**RE: Response Letter
Notice of Intent – NWD Trucking (SE49-0751)
100 Duchaine Blvd. – New Bedford, Massachusetts**

We have enclosed a response letter, revised HydroCAD calculations and a revised Site Plan in response to the comment letter prepared by Nitsch Engineering dated July 14, 2017 in regards to their review of the Site Plans and attached documents.

Nitsch Engineering Comments

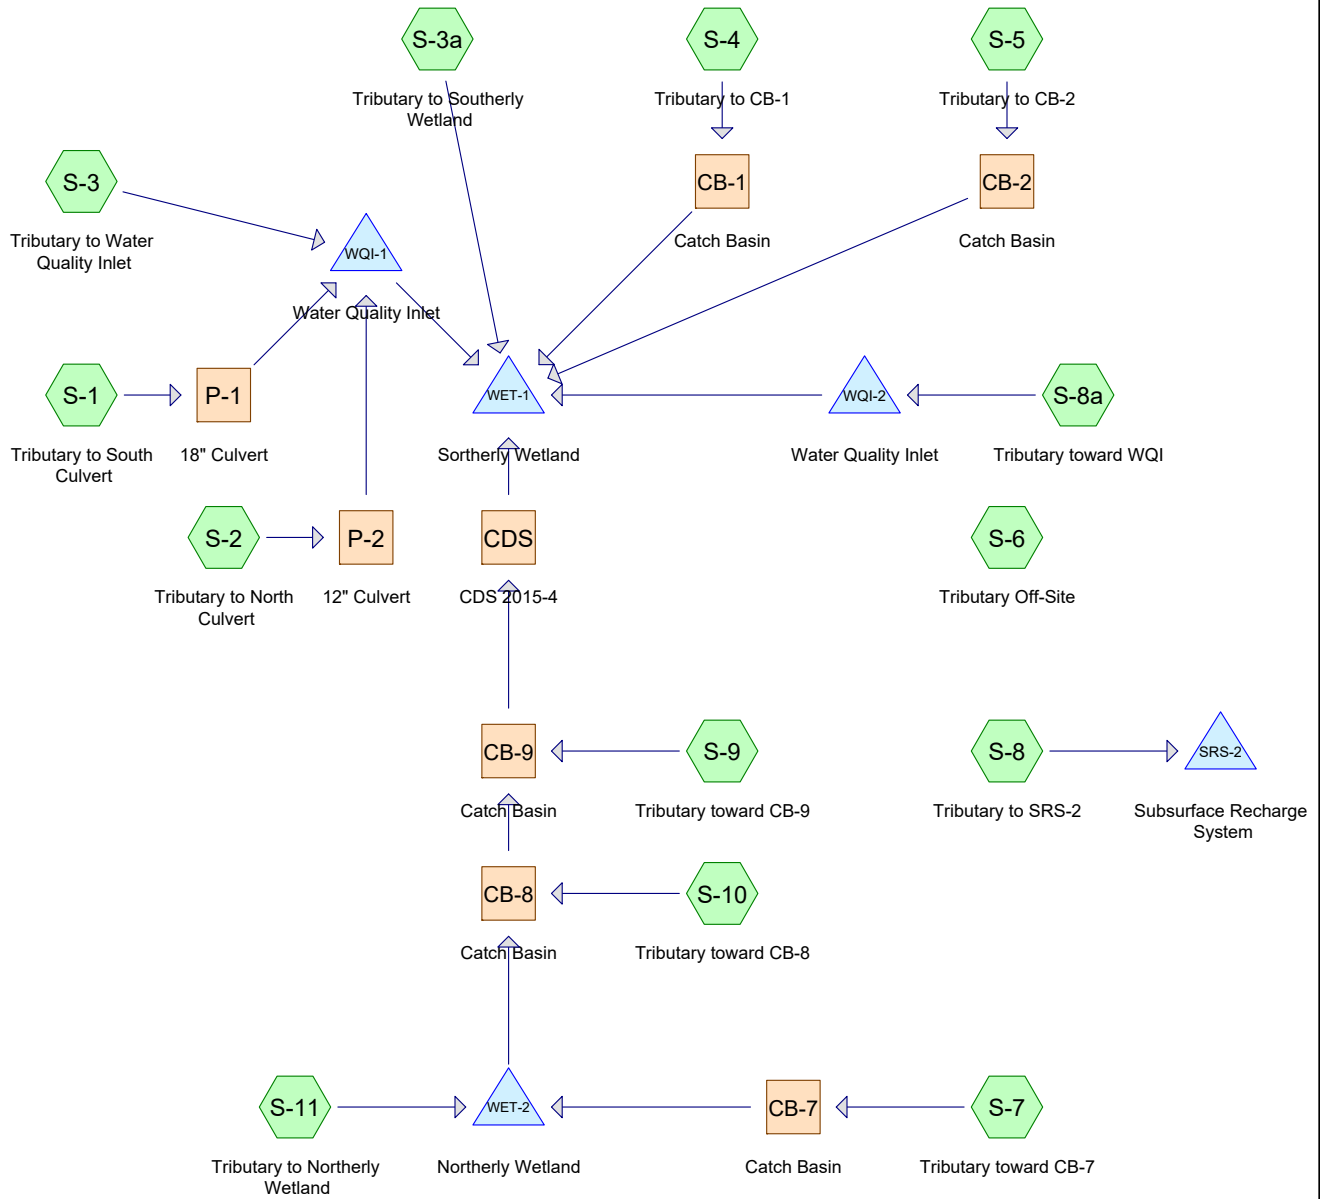
- a.) The existing conditions hydrologic calculations show the pipe flowing from CB-9 surcharged during the 10-year storm in the existing and proposed condition.*
- b.) The storm piping from existing CB-8 and CB-9 has been upgraded to 18-inch pipes on the plans. The calculations still show a surcharge from the pipe discharging from CB-9.*

a.) A substitute discharge pipe has been added to CB-9 to allow for the stormwater associated with a 10-yr storm to be handled more adequately.

16
8 CDS2025-5-C INLINE CDS SEPARATOR
NOT TO SCALE

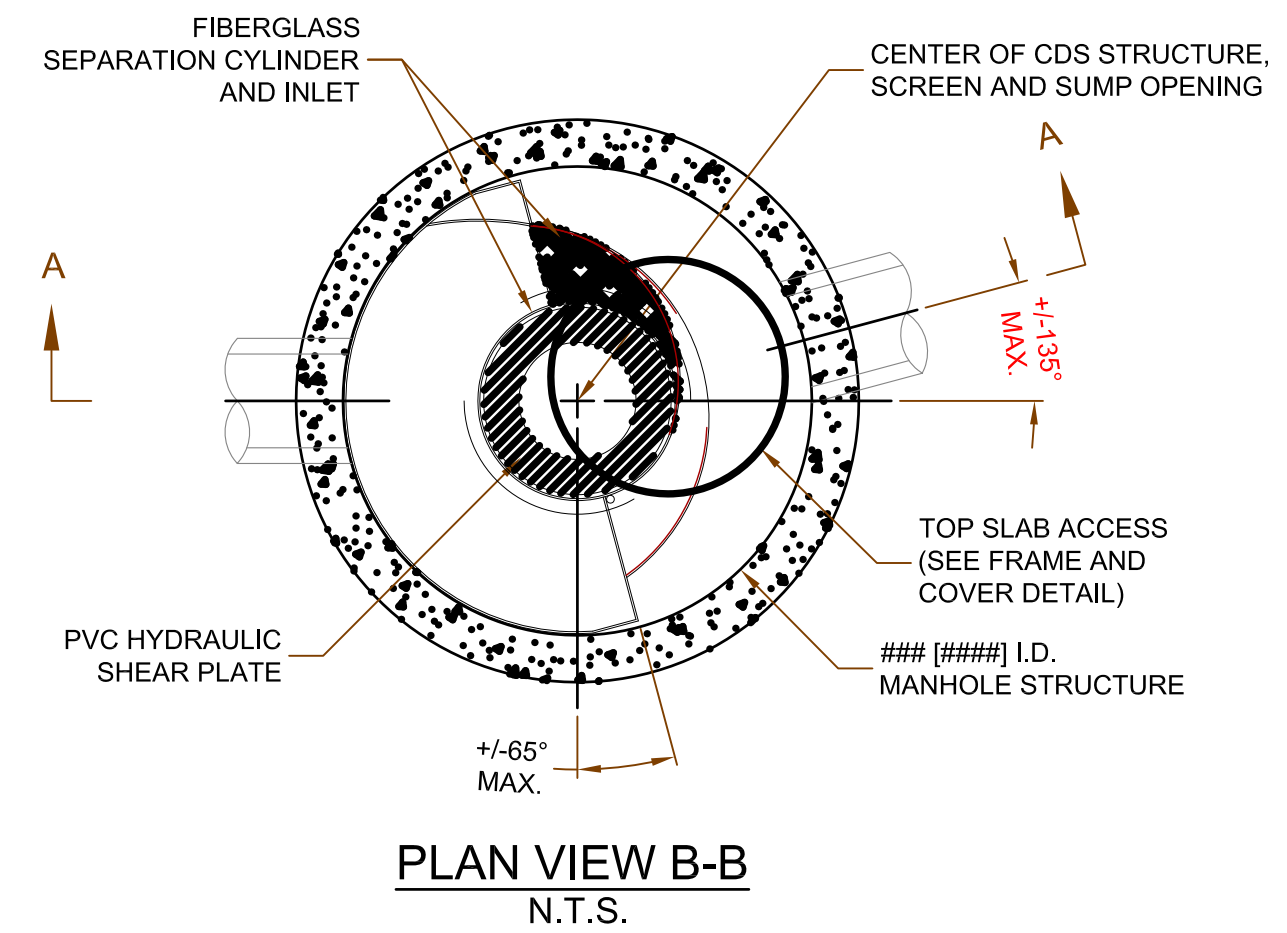
A CDS water quality unit was added to the plans to treat the water generated by the existing parking lot. The Applicant has not provided sizing information for this unit. Also, the unit was placed outside the existing parking lot adjacent to the wetlands pocket on the south side of the site. The unit is well within 25 feet of the wetlands line. A detail of this unit has been added to the plans. Sizing information should be provided.

The proposed discharge from the CDS unit, including rip-rap pads, should be shown on the plans. The current plan does not show a discharge pipe or rip-rap pad. The applicant has indicated that no rip-rap or discharge pipes are proposed.

Sizing information for this unit has been attached with this response.

The CDS unit was to be placed along the existing discharge pipe that connects CB-9 with the existing BVW to treat stormwater prior to discharge to the BVW. The location of the unit has been changed to allow for a more appropriate point of discharge with a rip-rap pad.
